BOARD ACTION REPORT – APPEALABLE ITEM

Project Name: Townhomes at 214 4th

SITE PLAN REVIEW AND APPEARANCE BOARD STAFF REPORT

Application Type: Class V Site Plan, Landscape Plan, Architectural Elevations and Landscape Barrier Waiver – Townhomes at 214 4th

Proposed Site Plan & Data

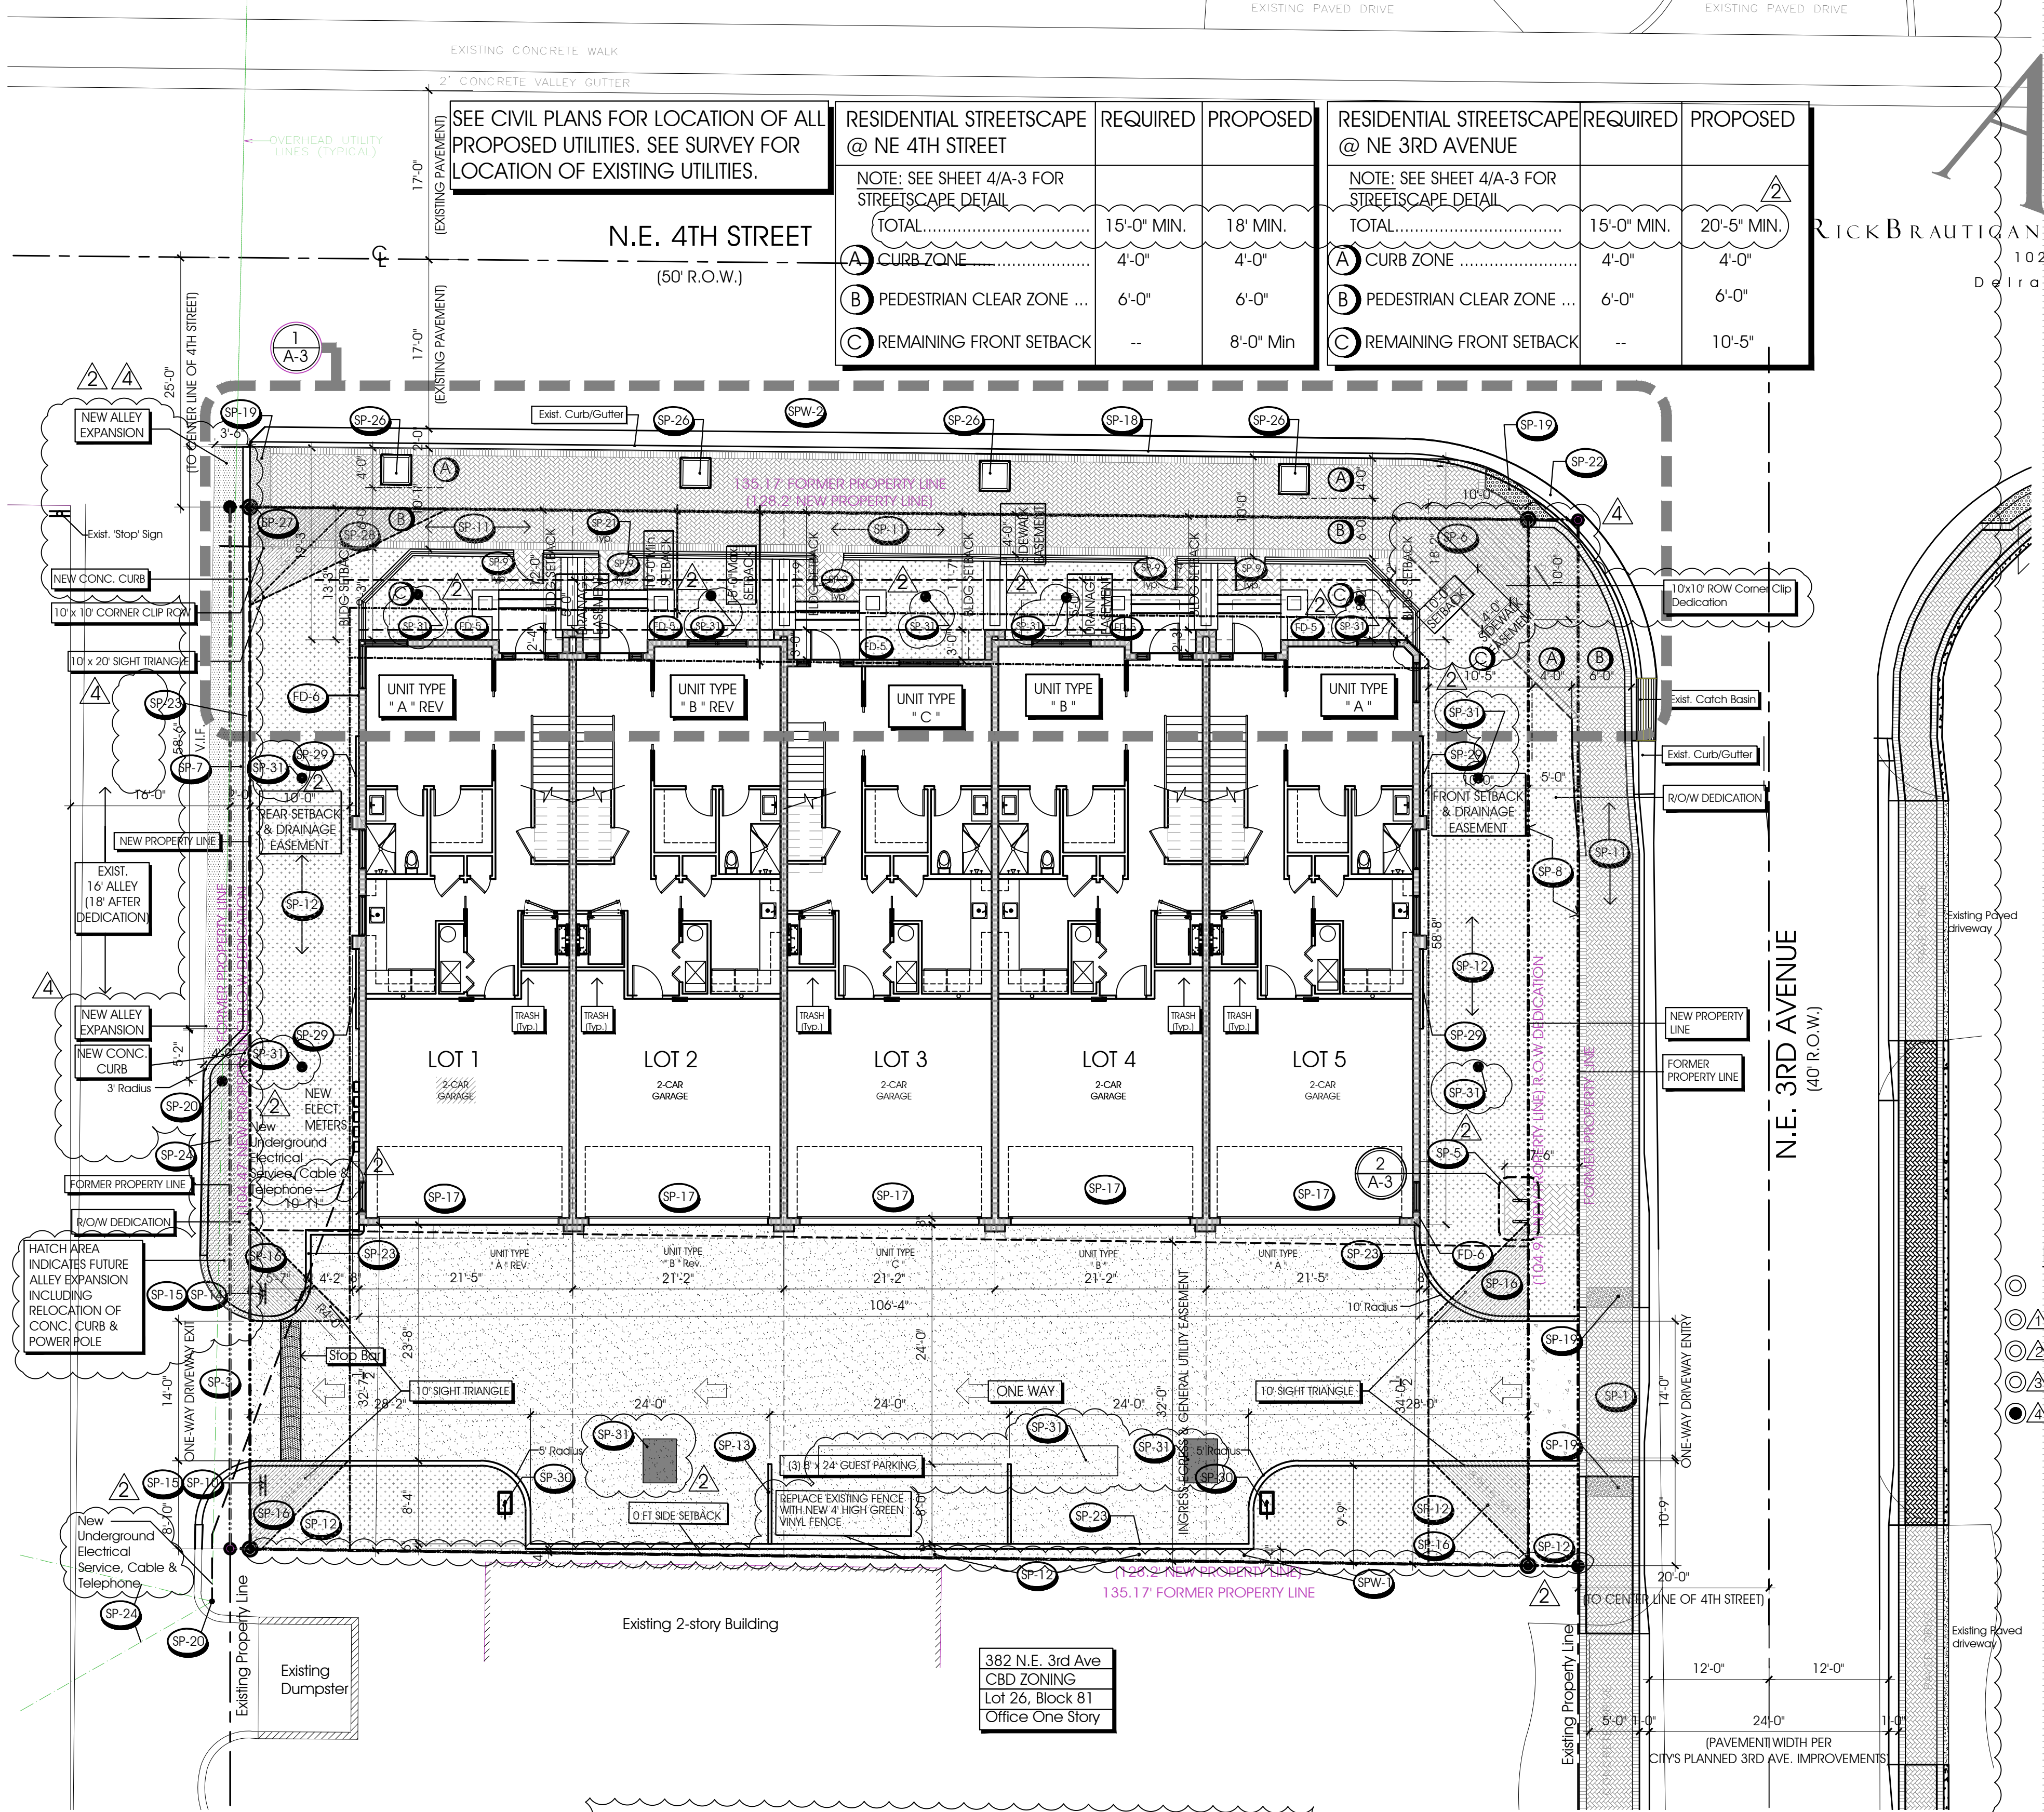
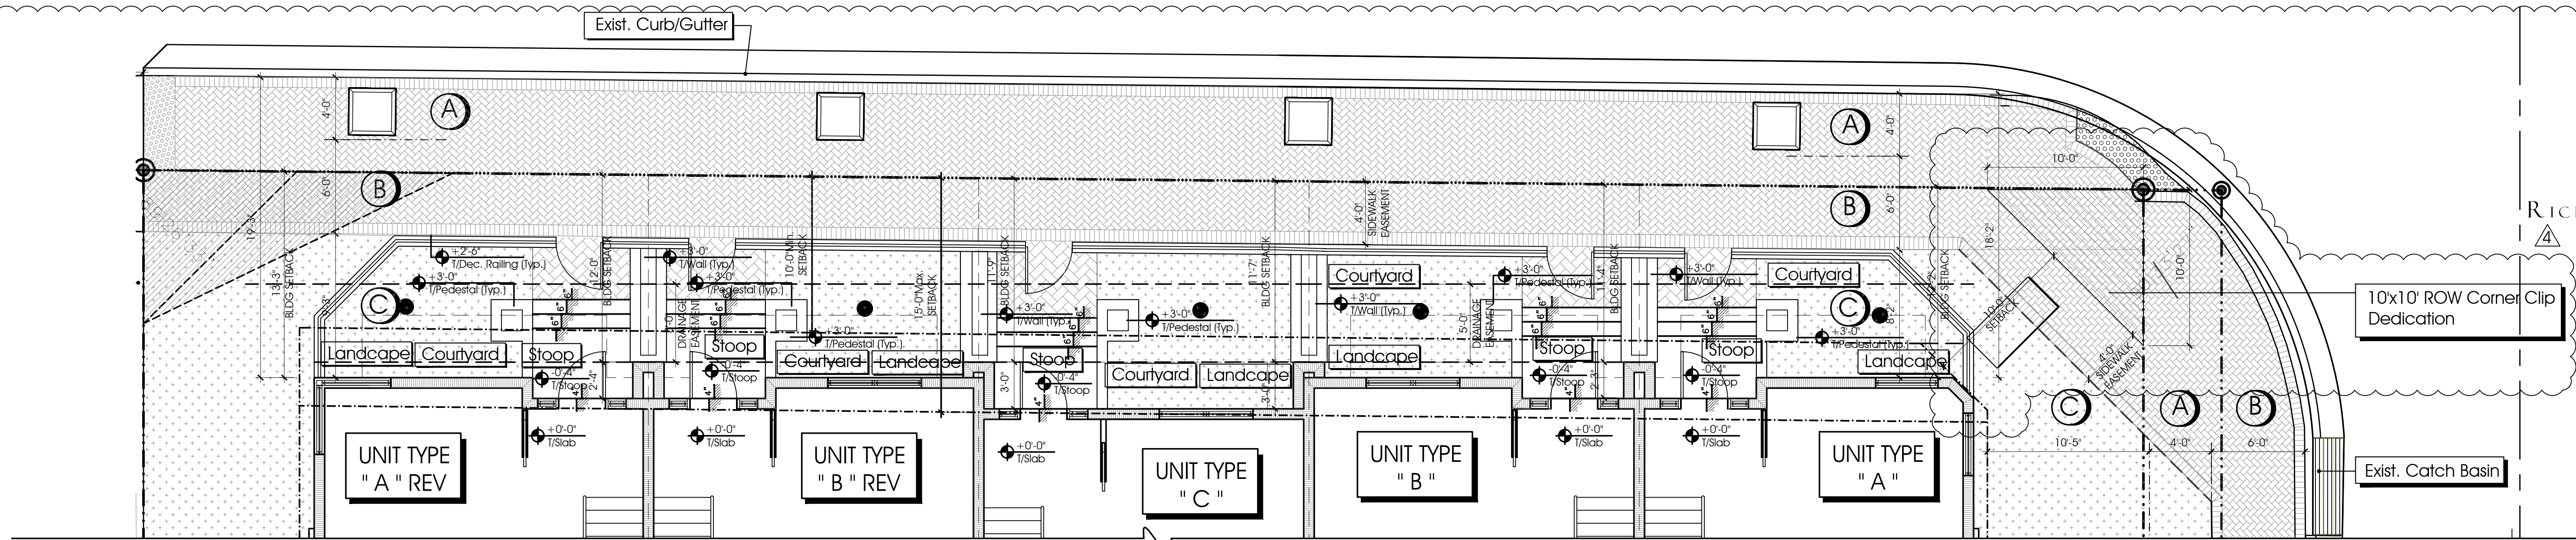
The parallel parking provided for required guest spaces is located closer than 5-feet from the property line. The applicant is requesting to reduce the barrier width from 5'-0" to 1'-0" for the length of the proposed parallel parking spaces (72-feet). The relief from the 5-foot width would allow for a safer back-out and maneuvering distance from the garages while maintaining the width of the parallel parking guest spaces.

Move approval of the waiver to LDR 4.6.16(H)(3)(d) which requires a 5-foot wide landscape barrier requirements where one-foot is proposed for **Townhomes at 214 4th** by adopting the findings of fact and law contained in the staff report, and finding that the request is consistent and meets criteria set forth in Section 2.4.7(B)(5).
